Historic Preservation questions and concerns:

Board Room Remodel
Fresno Unified School District
Fresno, CA

Fresno Unified School District Education Center Remodel Project Existing Exterior at Decorative Column

EXHBIT 2A

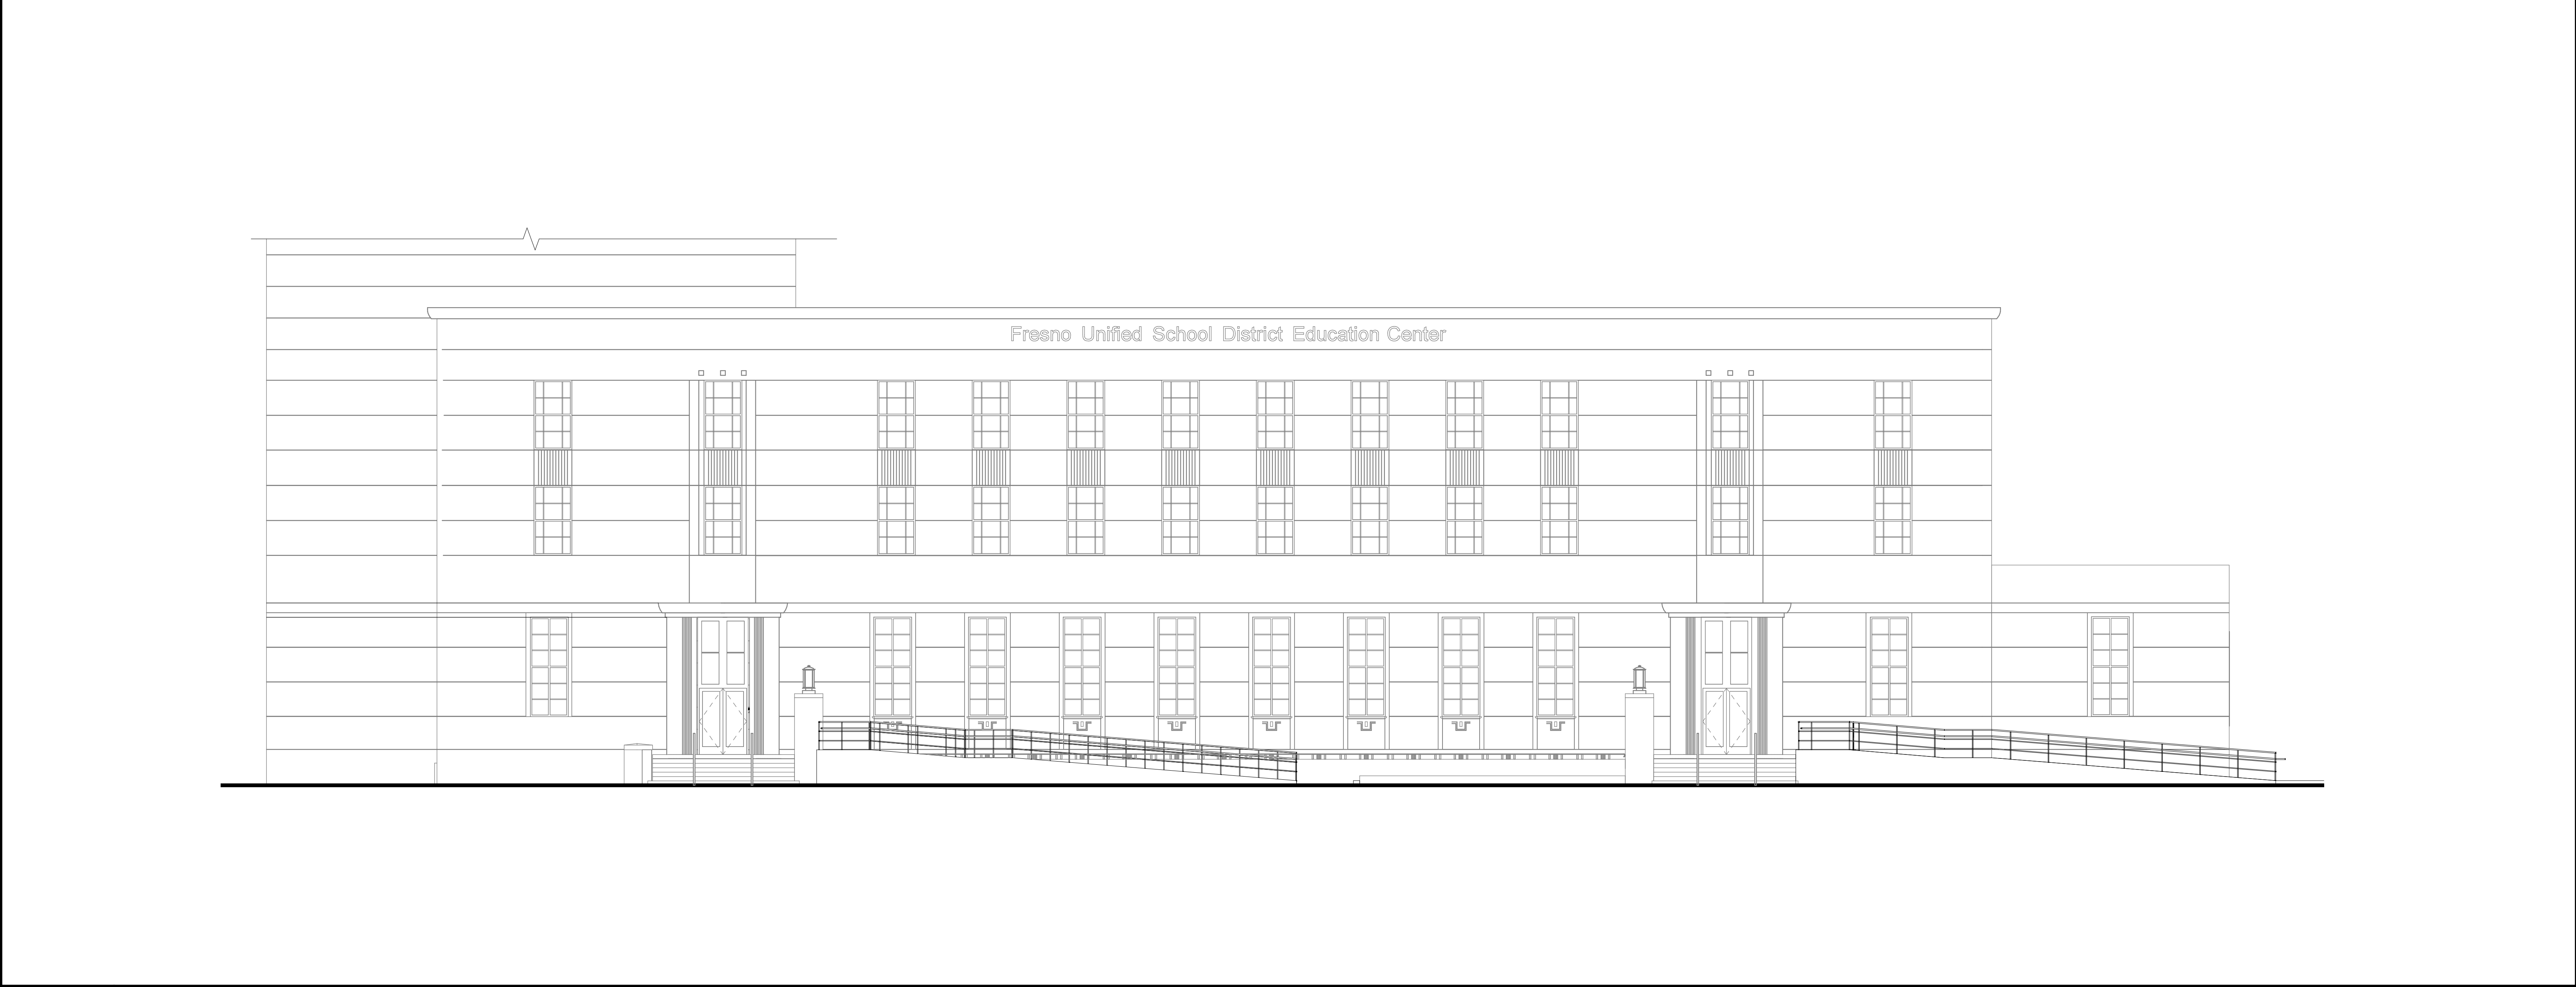
1. A1 & J1 (pl 42, 43) are detailed elevations of the ramps, however please provide an existing and proposed drawing to scale of the entire SE elevation facing Tulare St. including the building wall in detail, so that we could better assess the ramp in reference to the façade.
See Exhibit 2A - Exterior Elevation

4. The existing rail with the ornate pickets which is located between the landscaping and light well, will this be removed/demolished? Can this be replicated in the ramp designs?
Only a small portion is being demolished. The existing remaining original rail will still be visible.
Refer to Exhibit 2A - Exterior Elevation.

5. Will the decorative wall feature below the windows facing Tulare St. be totally obscured by the ramp location?
Wall Feature will visible through open guard-railing. Refer to Exhibit 2A - Exterior Elevation.

EXHIBIT 2B

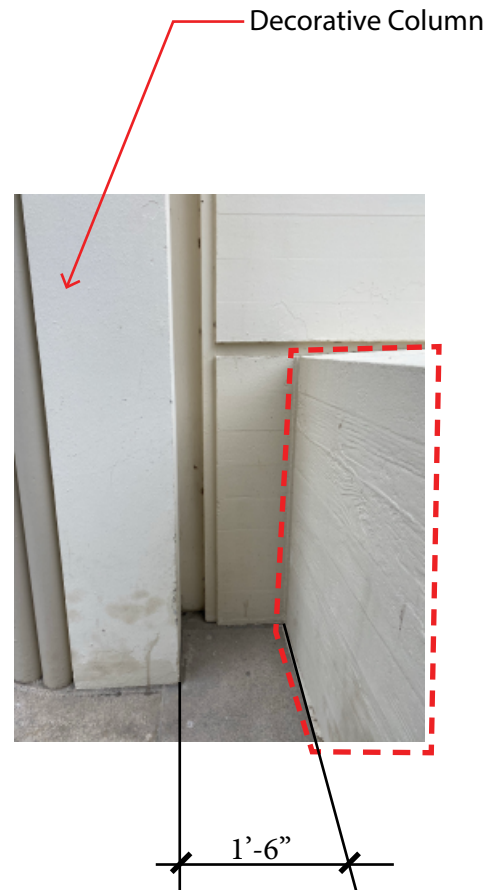
What are the impacts to the decorative columns surrounding the door entrances, given the size and scale of both ramps?

2. The property lines are a hard to make out on some of the plans.
Property Line was not indicated on Plans.
3. What are the impacts to the decorative columns surrounding the door entrances, given the size and scale of both ramps?
No Impact - There is +1'-6" space between the decorative column and the demo/new work.
See Exhibit 2B - Existing Exterior at Decorative Column

Excerpt from Drawings A7-SD/A101 (Not shown to Scale)

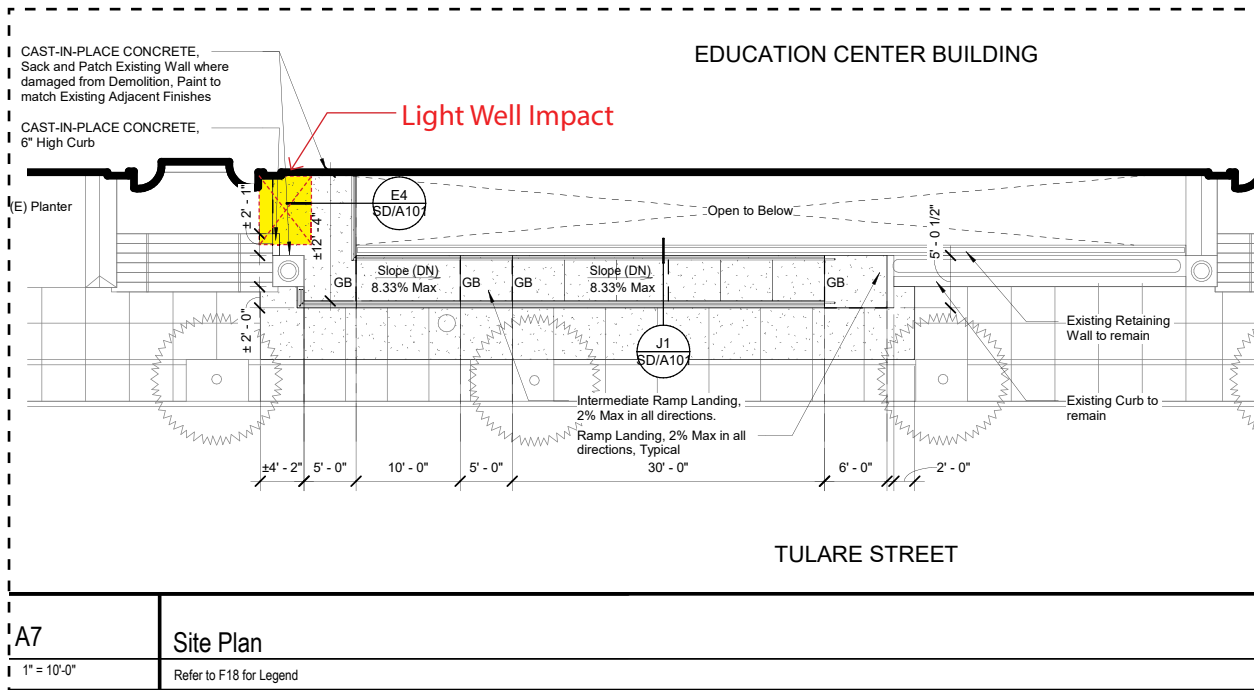
1. What are the plans for the light well?

The ramp was design to keep the light well open to below to allow light into the Basement.
Approximately 5'-0" x 6'-7" of the light well at the West end will be covered to accommodate the Ramp landing. Refer to **Site Plan on A7-SD/A101**.
